WESTSIDE SUBWAY EXTENSION PROJECT

Contract No. PS-4350-2000

Response to Preliminary Review Comments of Century City Area Fault Investigation Report by Shannon & Wilson

April 17, 2012

Figure A-18: Plan of Aerial Station Concept

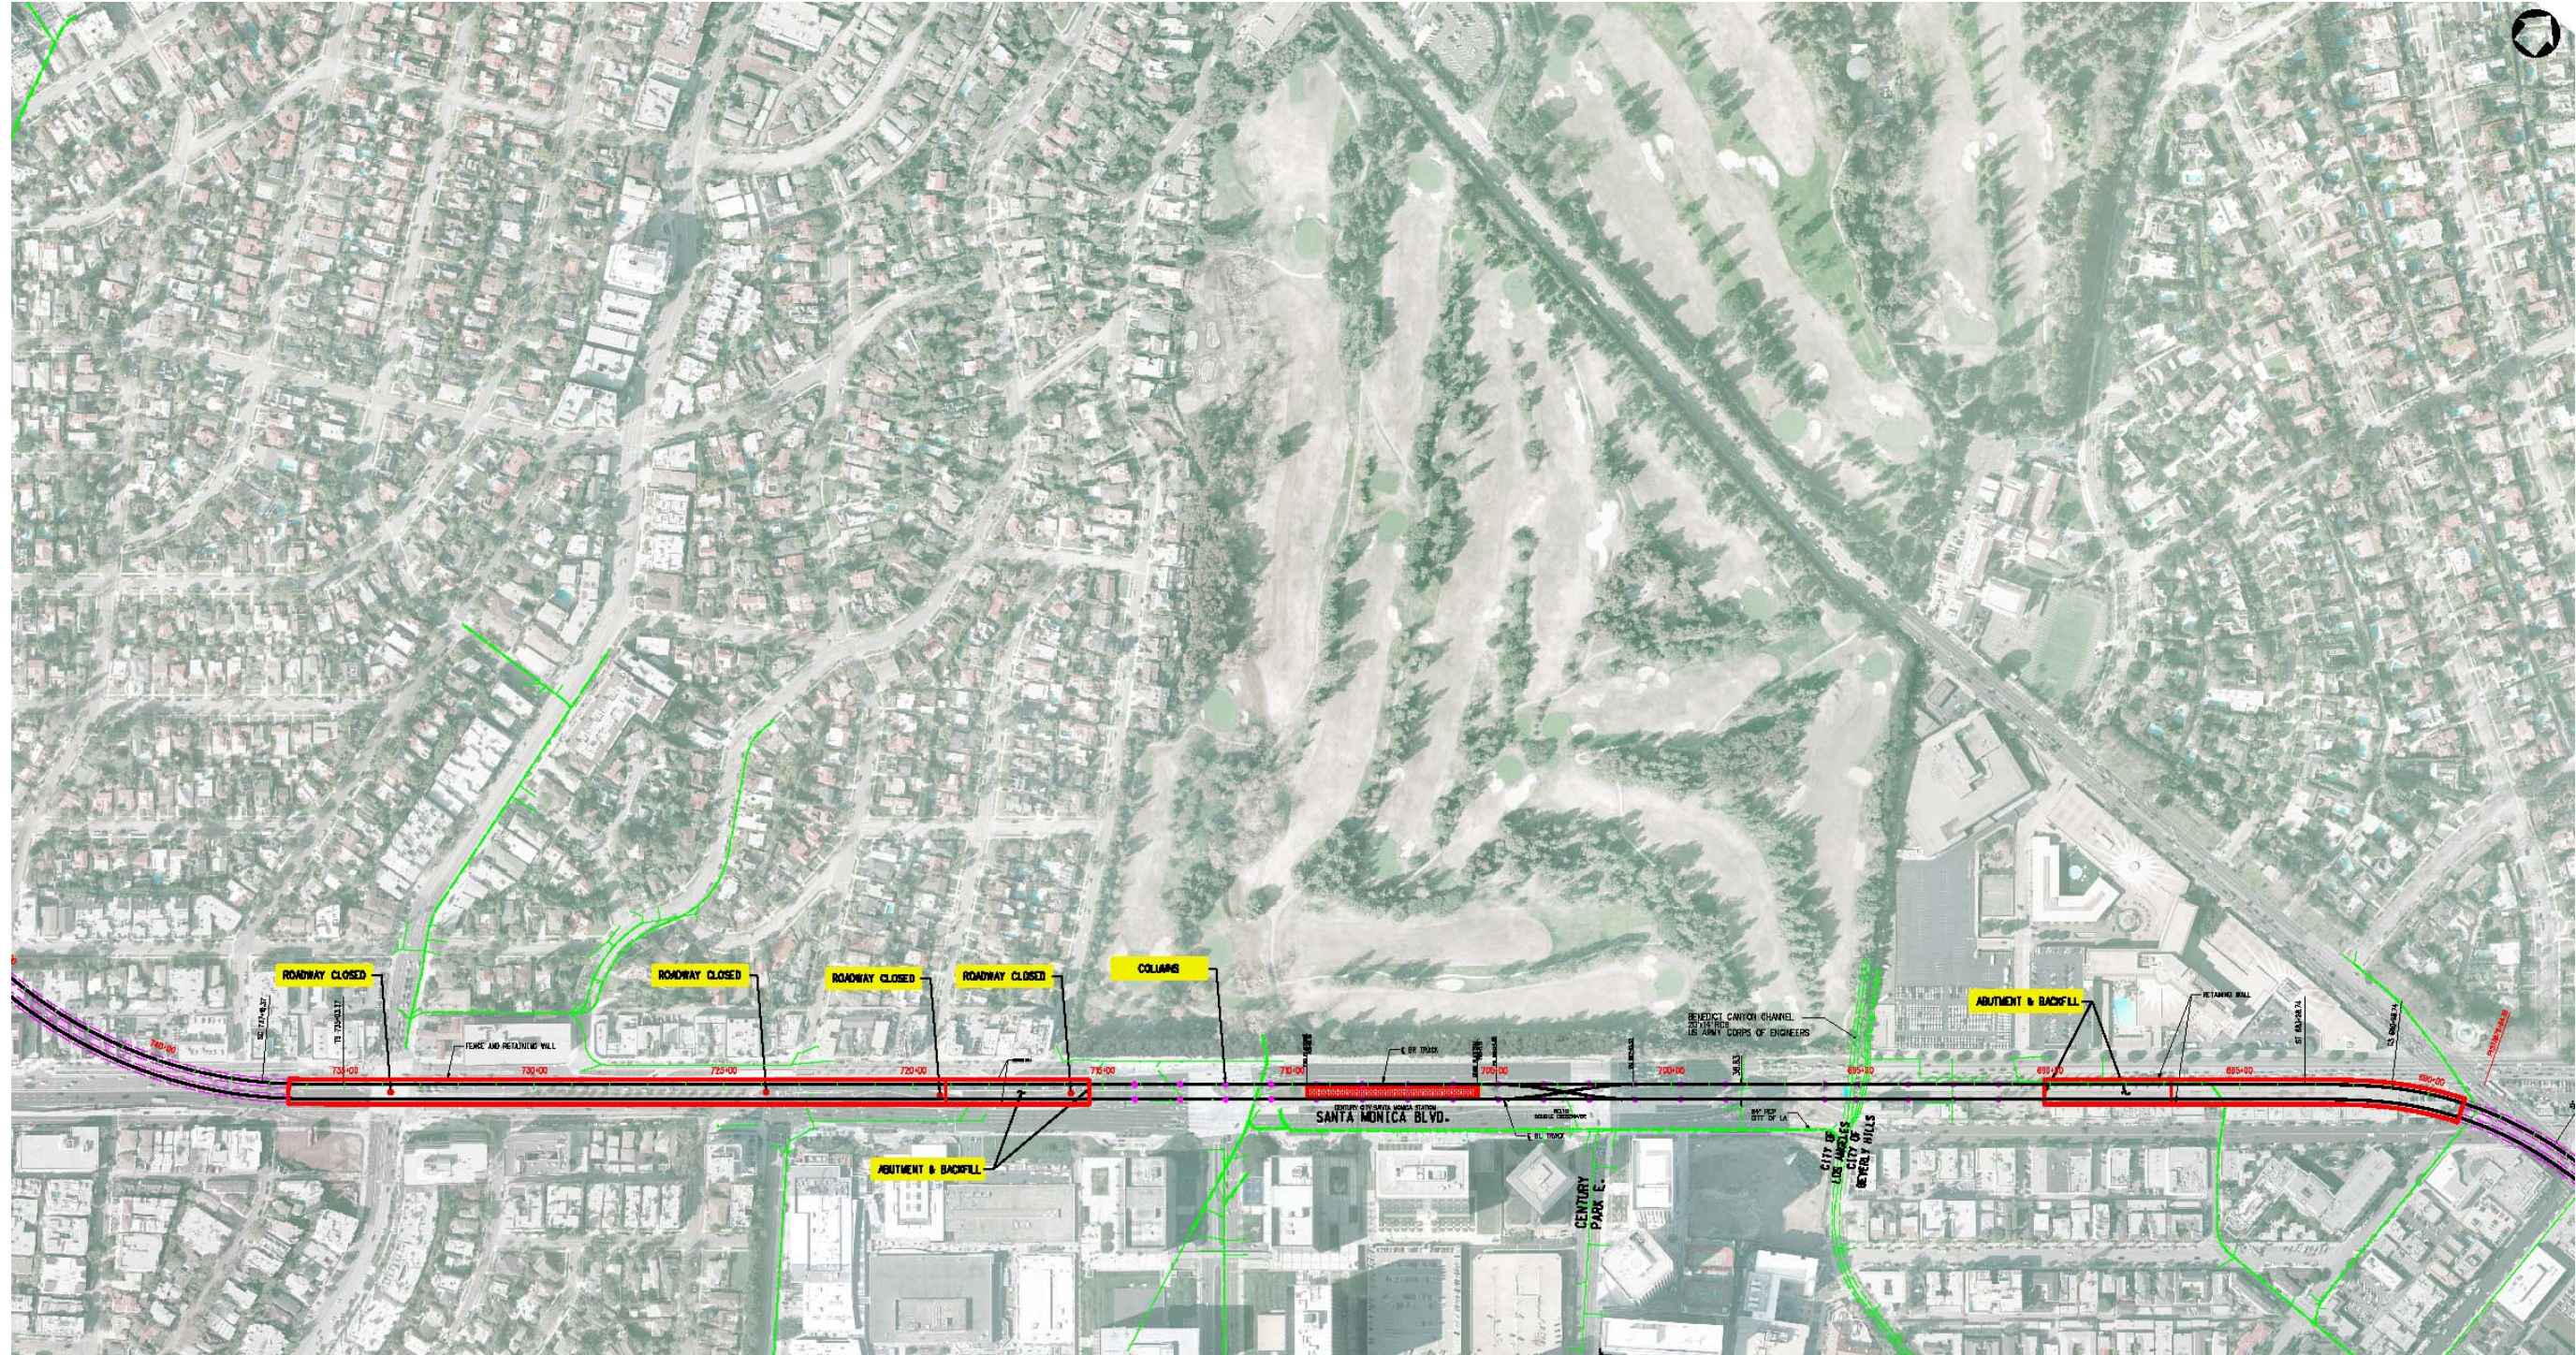
Putting the Station in an aerial configuration was suggested as an option to remove some of the traffic impacts associated with the at-grade alternative, but this would introduce other issues. The concept for this alternative shown in Figure A-18, shows the east portal of the proposed at-grade section at the intersection of Wilshire and Santa Monica Boulevard. The transition trench from below ground to aerial would extend about 800 feet west of Wilshire Boulevard. The train would then transition from at-grade to aerial on an aerial structure that would be constructed in the center median of Santa Monica Boulevard. The trains would run in an aerial configuration with a crossover track and an aerial station between Century Park East and Avenue of the Stars. On the West side of the station, the structure would descend to grade and then enter another transition trench from at-grade to below ground which would extend for another 2,100 feet. The combination open trench and above-ground section would be about 5,800 feet in length, extending from Wilshire Boulevard to beyond Beverly Glenn. Access to the station platform from Century City would need to be grade separated over the tracks and Santa Monica Boulevard as shown in Figure A-19.
